STATE OF ALASKA
LIBRARY ARCHIVES MUSEUM

Submittal #: 06 41 00-6.1

Specification: 06 41 00 Architectural Wood Casework

Description: Gift Shop Casework Shop Drawings

① ENLARGED RCP - GIFT SHOP
1/8" = 1'-0"

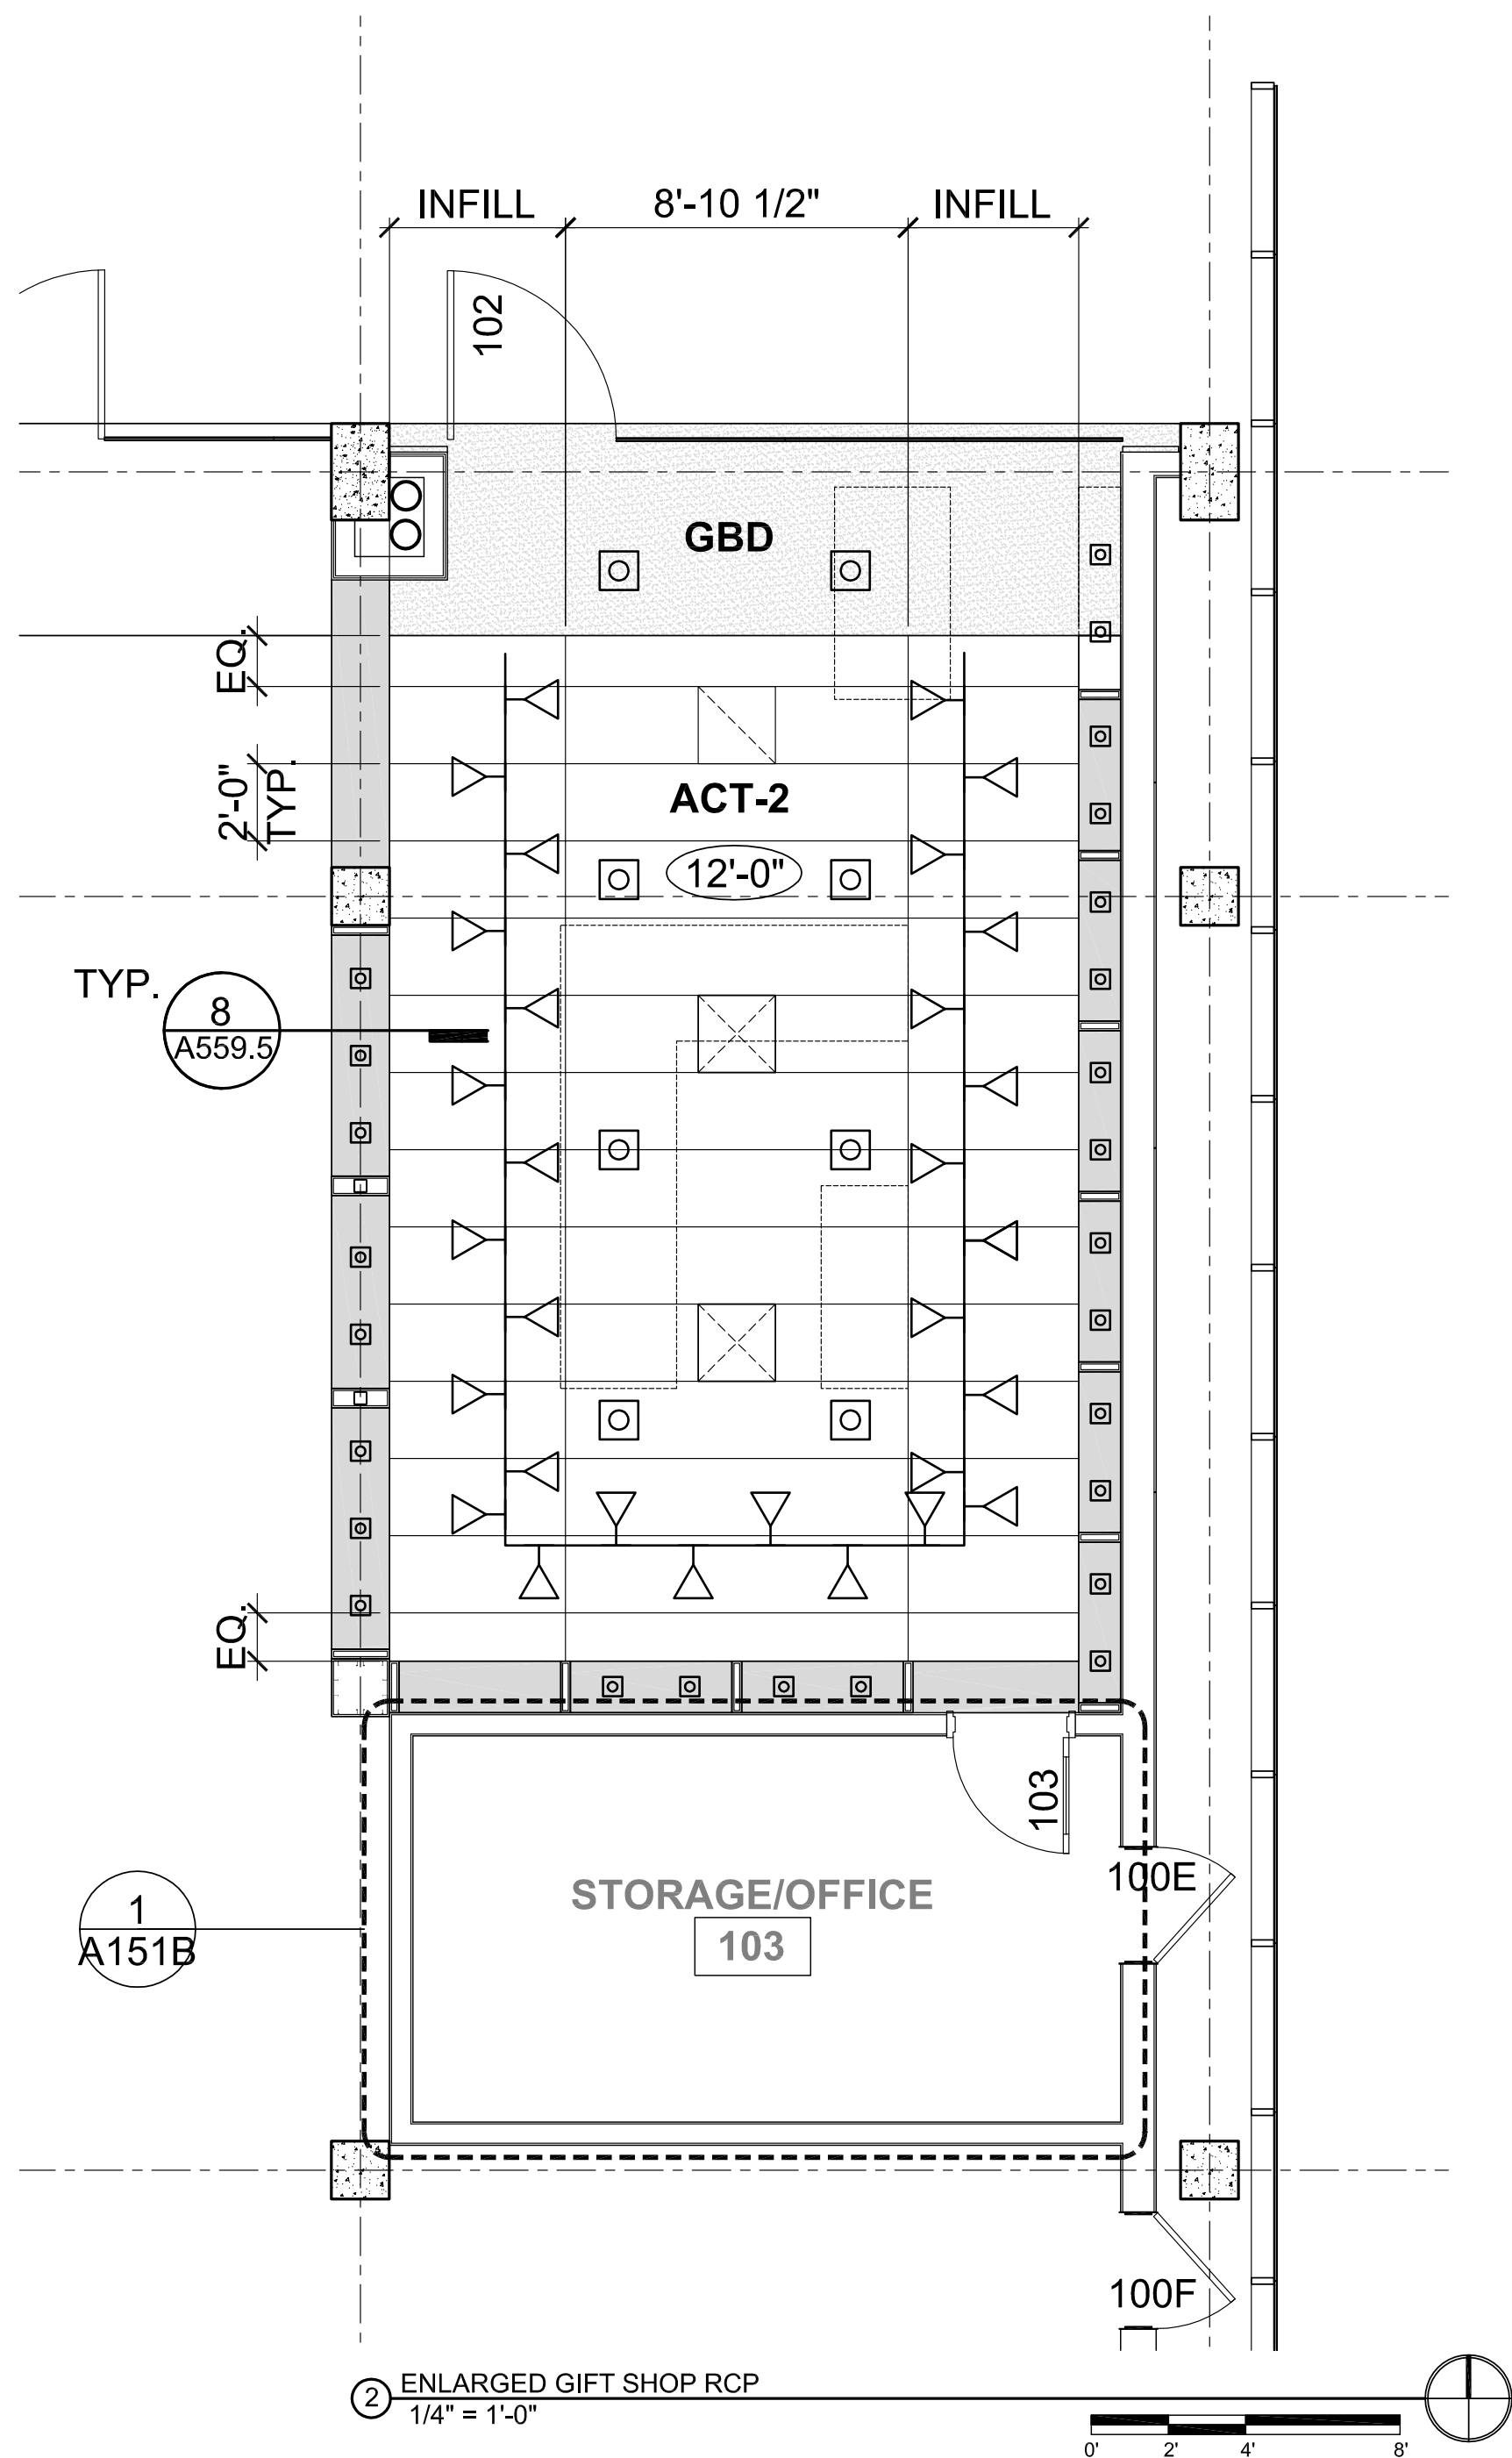
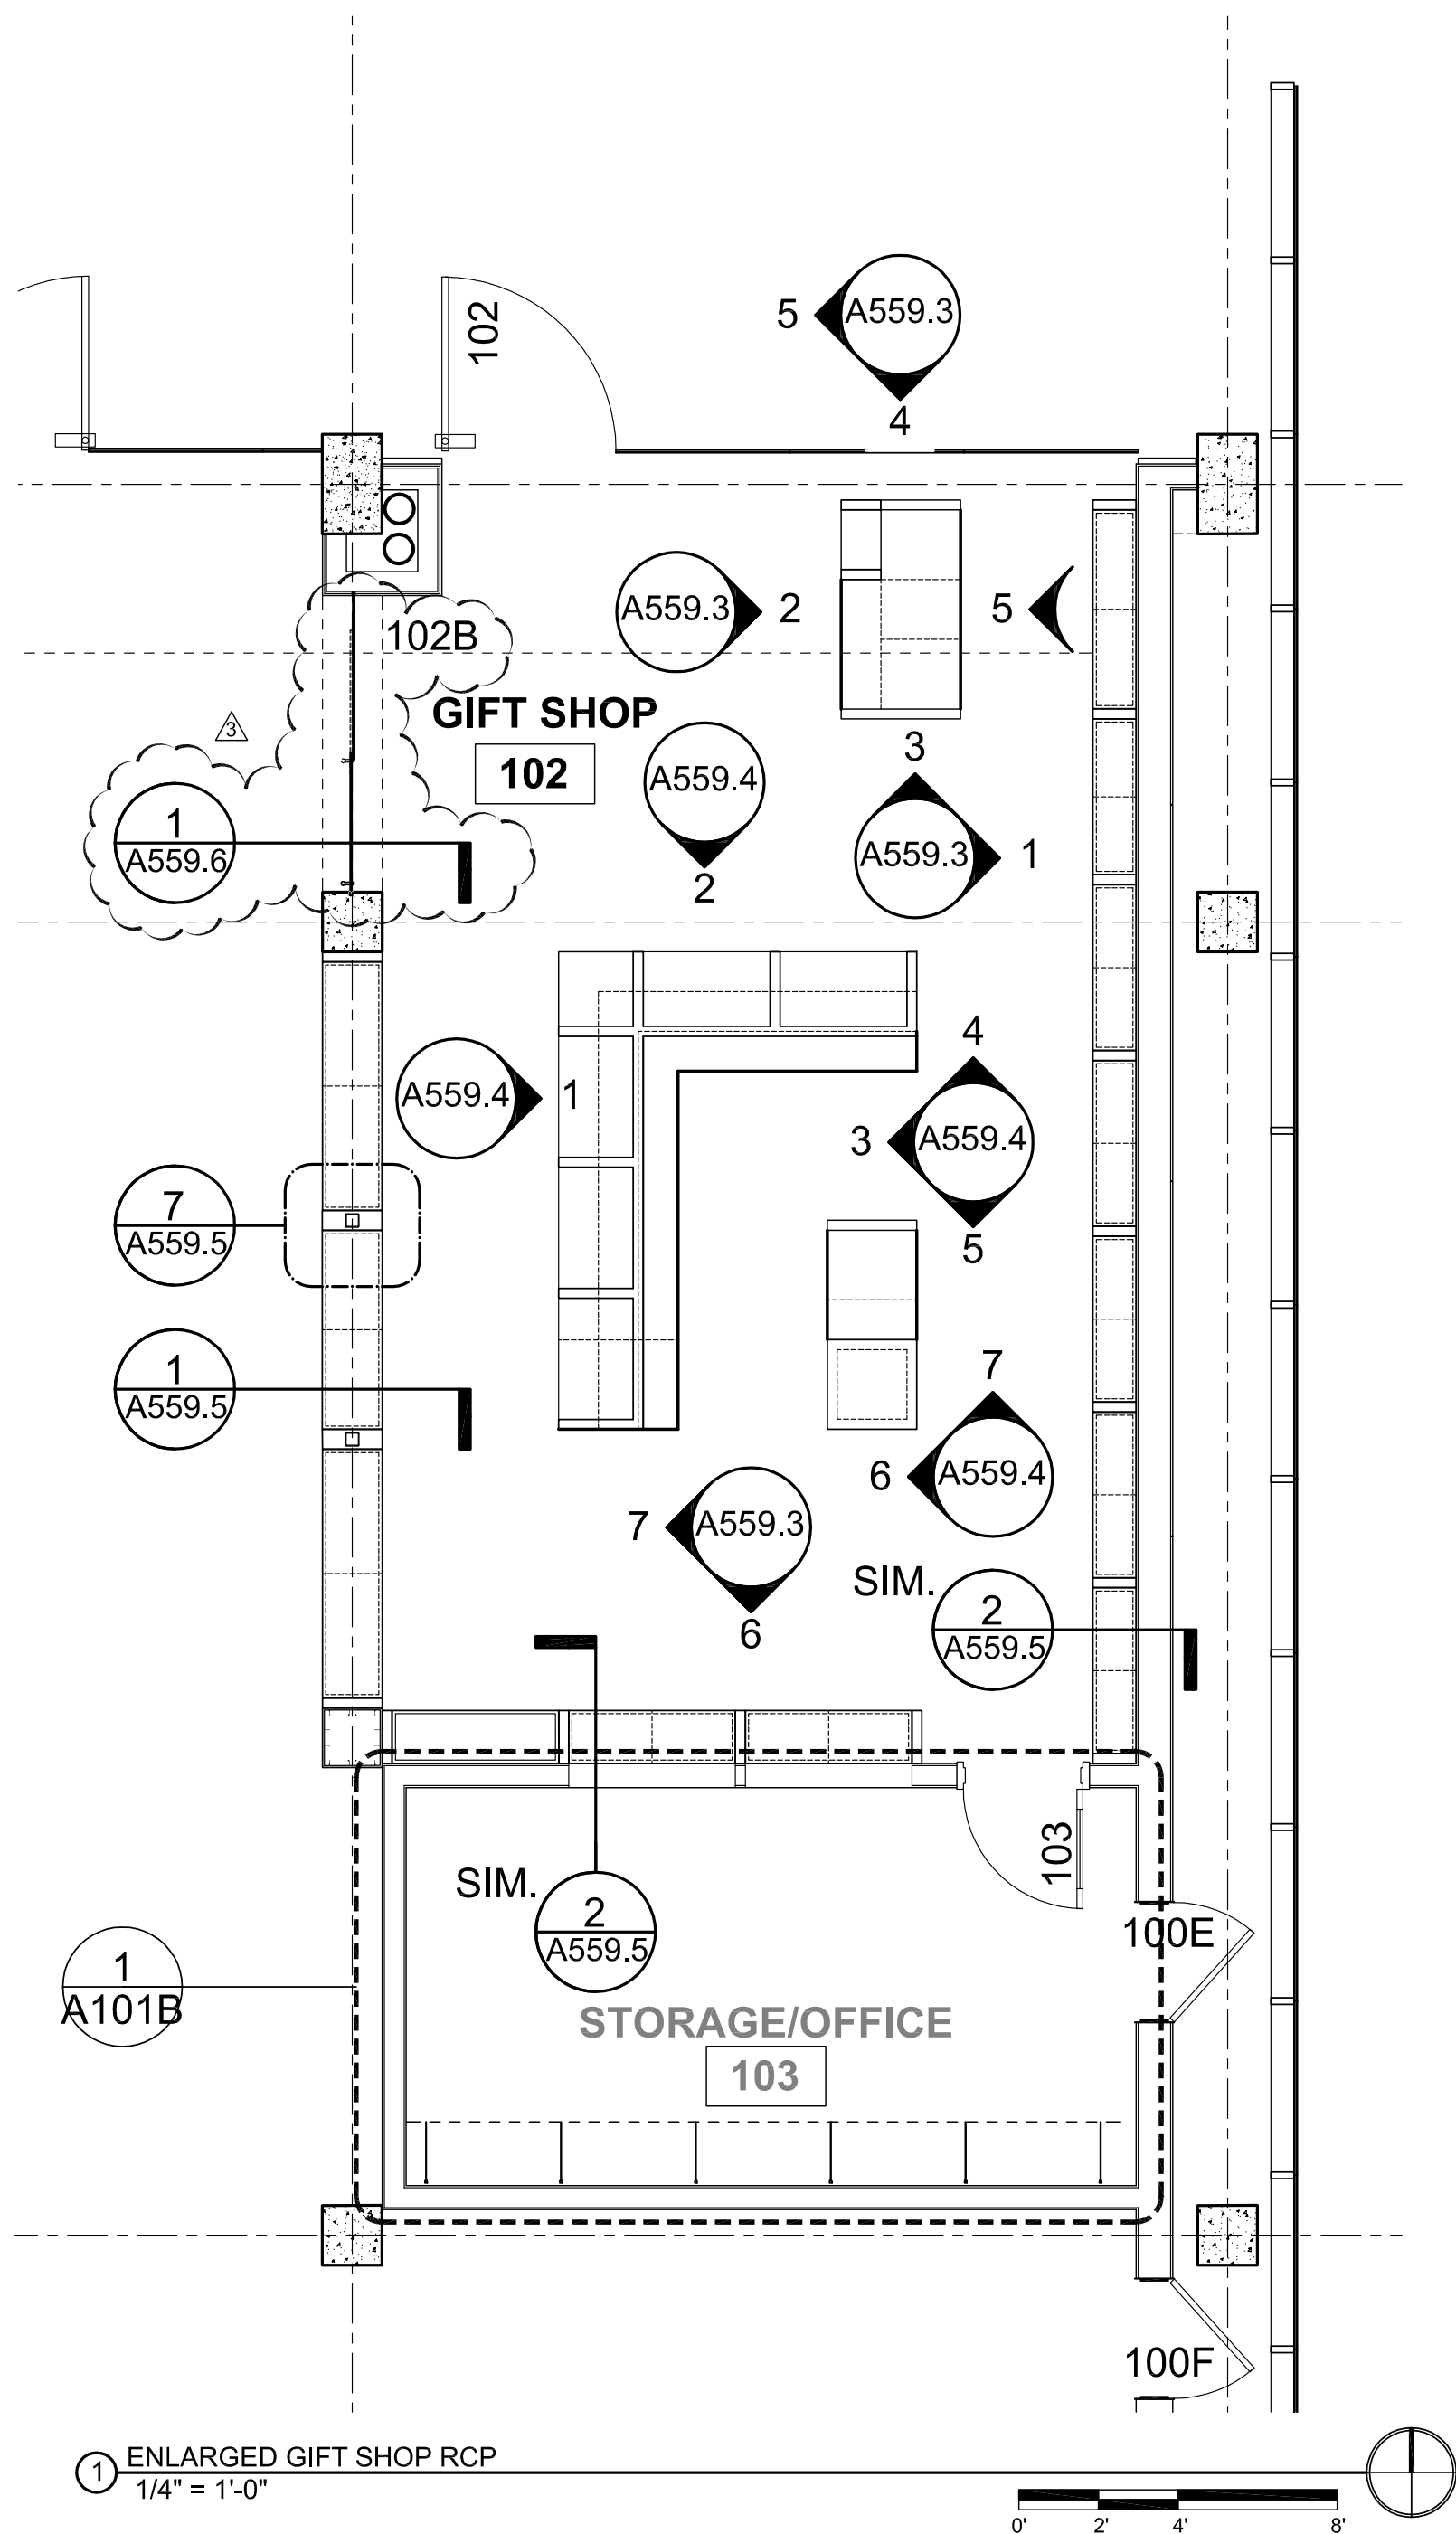
12/17/14 - PROVIDE CHANGE TO IB
PER RFI, LIGHTING TRACK WITH
PRODUCT DATA AND DETAILS.

7 EAST ELEVATION - DISPLAY CASES & STORAGE
1/2" = 1'-0"

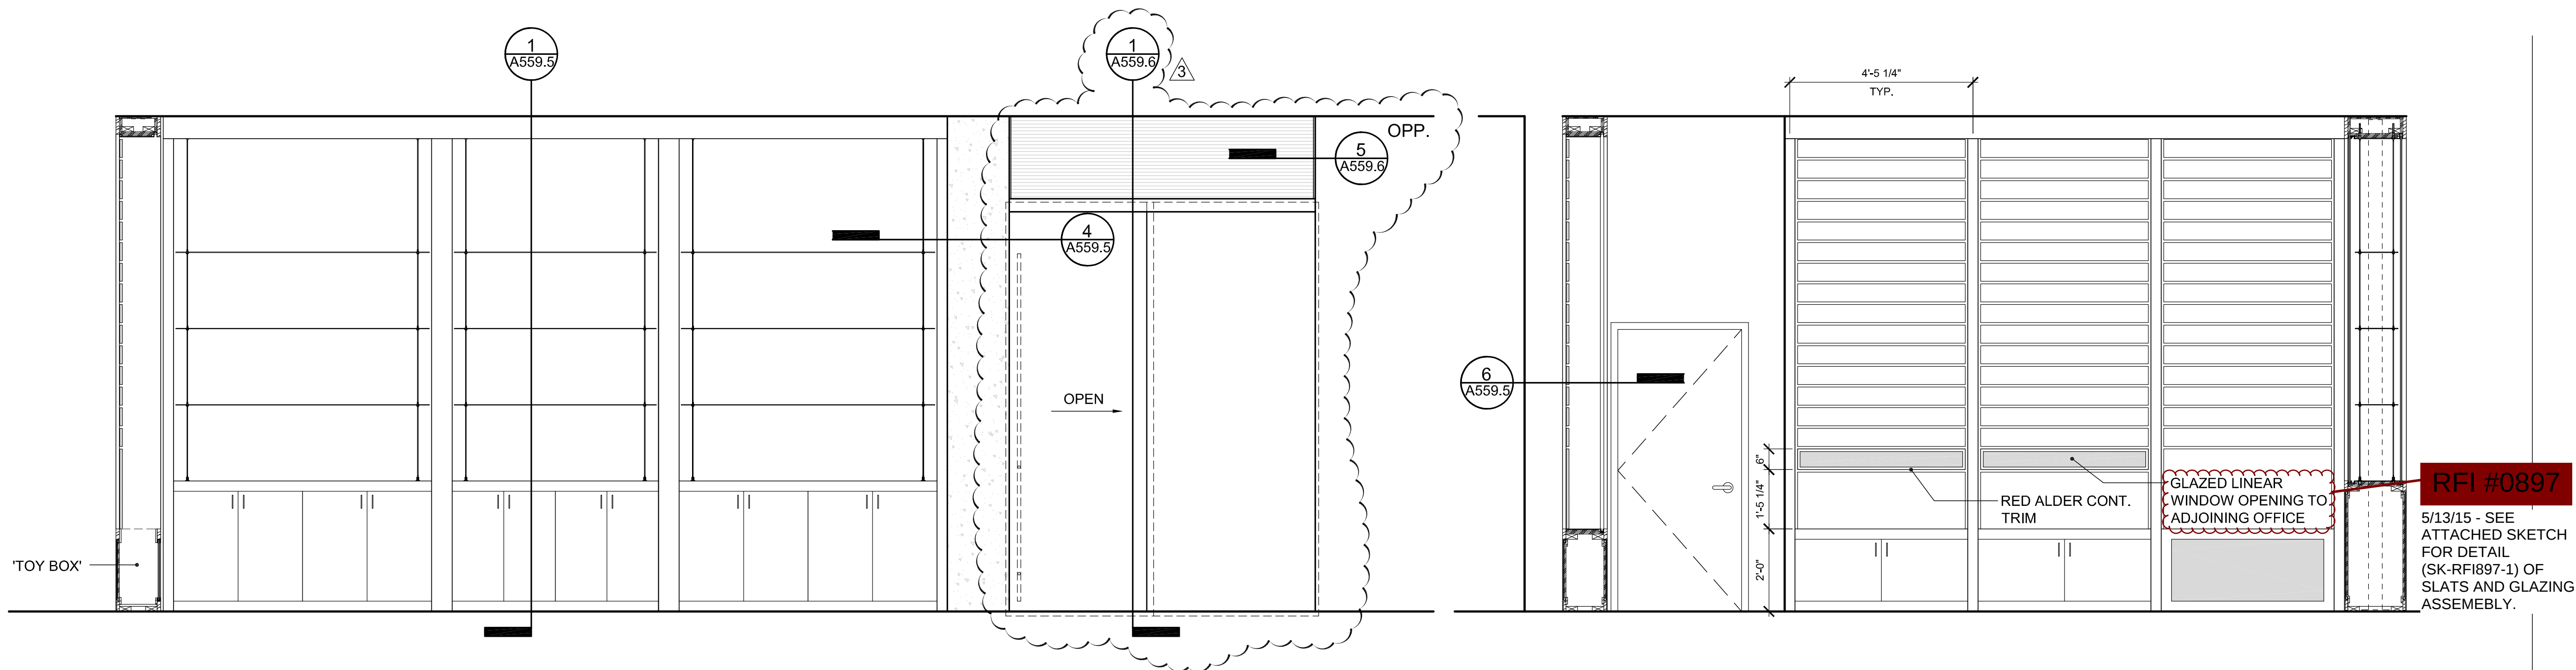
6/3/15 - SEE ATTACHED SKETCHED SKETCH SK-RFI931-1 FOR ADDITIONAL FINISH CLARIFICATIONS AND SECTION VIEWS.
